**NORTH CAROLINA DIVISION OF
AIR QUALITY**

Application Review

Region: Washington Regional Office
County: Pitt
NC Facility ID: 7400021
Inspector's Name: Yongcheng Chen
Date of Last Inspection: 09/27/2017
Compliance Code: 3 / Compliance - inspection

I. Purpose of Application

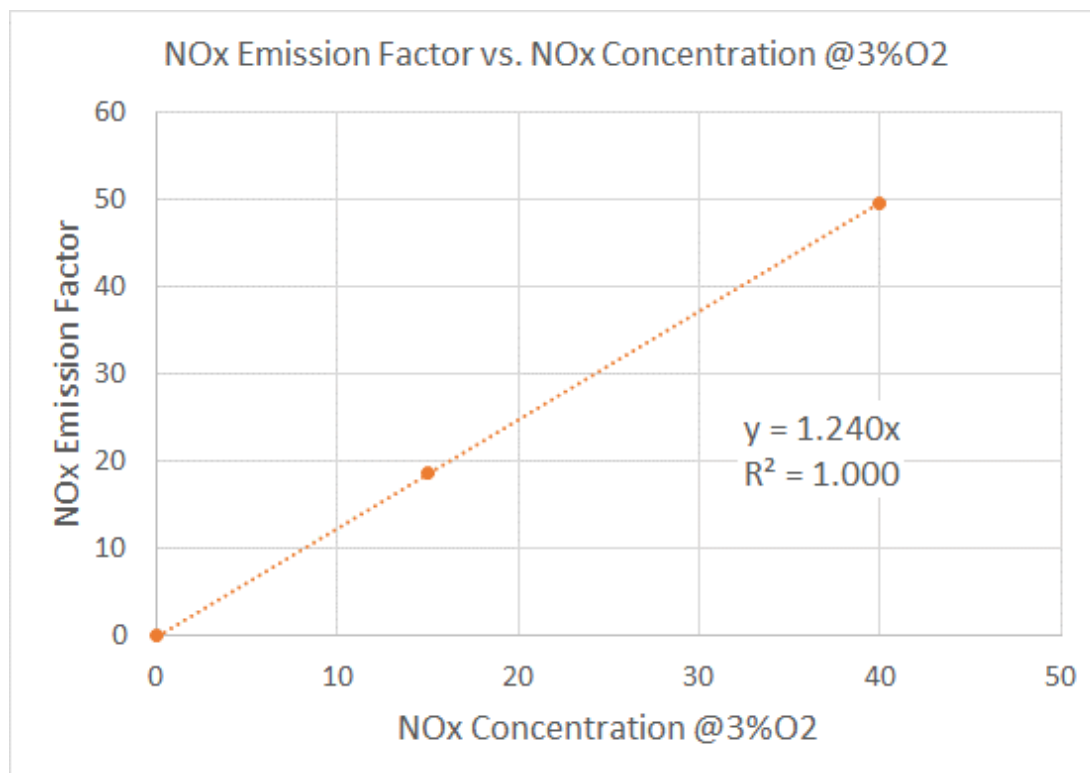
If you plot these two points, you can calculate a correlation equation to provide a NO_x emission factor for any measured NO_x concentration measured at 3% O₂. The graph provided below shows a correlation factor of 1.24, which means the proper NO_x emission factor for each unit would be the measured NO_x concentration @3% O₂ times 1.24. The NO_x mass emission rate would be calculated by multiplying the NO_x emission factor (i.e., 1.24 times the NO_x concentration @3% O₂) times the natural gas combusted in units of million standard cubic feet.

With the proposed change in the DAP 1-4 hot oil furnace operation and documentation showing NO_x concentrations at 3 %O₂ for the hot oil furnaces varying from source to source. The current equation in the permit does not accurately reflect NO_x emissions. DSM is proposing to update the equation to reflect both measured NO_x concentration values and/or certified from the manufacturer NO_x concentration values.

$$E_{NOx} = (20 \times Q_{FO2}) + (1.24 \times C_{NOx@3\%O2(i)} * Q_{ng(i)})$$
